E3633A-05C**S E R V I C E N O T E**Supersedes:
E3633A-05B**E3633A DC Power Supply****Serial Numbers: MY51240075 to MY53200002****Metal Strap Kit for tightening loose bumper and for fitting rear lock link in side-by-side rack mounting****Parts Required:**

Figure 1: Top view 3mm gap observed between two different chassis designs

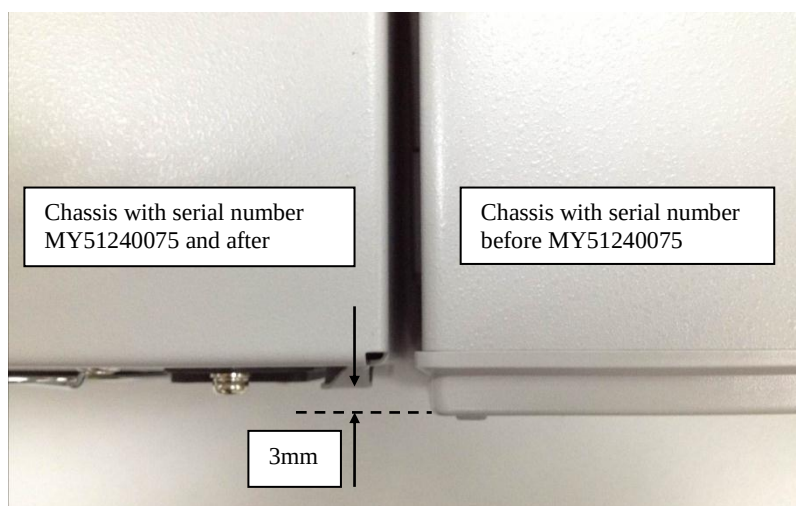
The chassis depth difference between the two designs is 3mm as shown in Table 1 and Figure 1 below.

Figure 2: Top view 3mm gap observed on rear lock link for side-by-side rack mounting

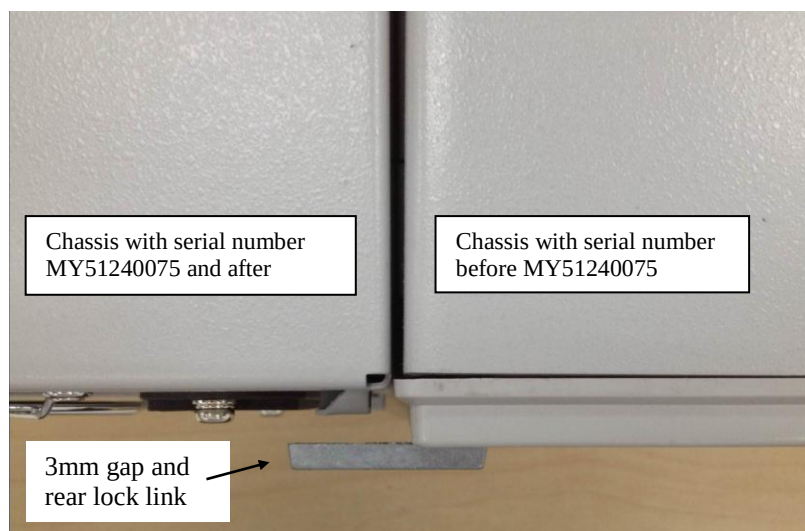
The 3 mm gap between the two different chassis may cause difficulties in securing them together using a rear lock link kit (part number 0050-2167) for side-by-side rack mounting as shown in Figure 2 below.

Use metal strap (part number E3631-07901), and stack the provided two metal straps together to form 3mm thickness and secure it with the provided screws on the rear lock link as shown in Figure 4 below.
